Crystal River Unit 3

Subject: Revised Response to a Notice of Deviation

FLORIDA POWER CORPORATION
NRC INSPECTION REPORT NO. 50-302/95-16
REPLY TO A NOTICE OF DEVIATION

DEVIATION 50-302/95-16-05

Figure 1

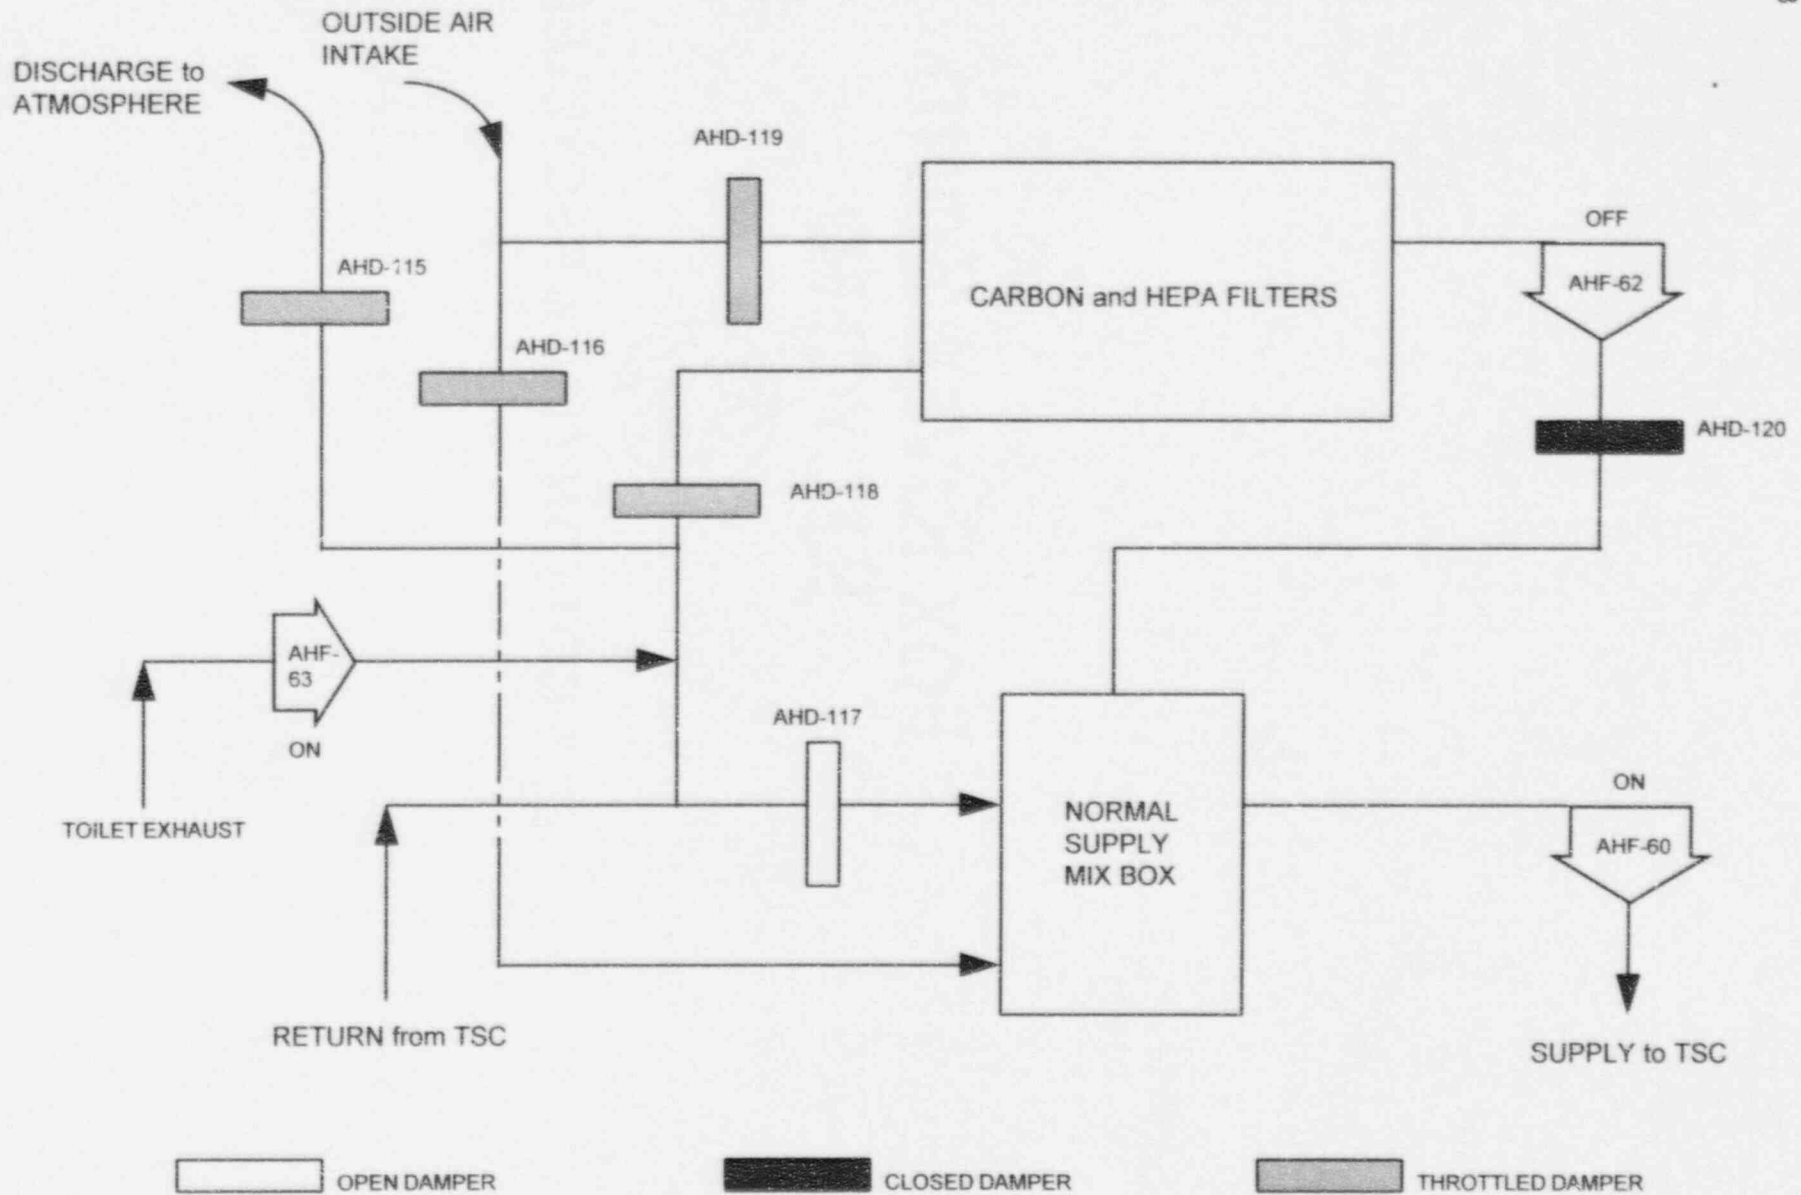
Three mechanical factors have been identified which adversely affected the system flows:

1. Fan performance substantially exceeded design flow requirements. This required throttling of system dampers to a point where slight changes had significant effects on system flows.
2. Motorized dampers were used to balance system flows. In conjunction with the excessive fan performance, repeatability of damper position when the system was cycled could have affected flows.
3. System operation relies on a positive building pressure to prevent in leakage and assumes zero leakage past the normal make-up damper (AHD-116) and relief air damper (AHD-115). These were found to be leaking. See Figures 1 and 2 for flow diagrams of the original TSC Ventilation system.
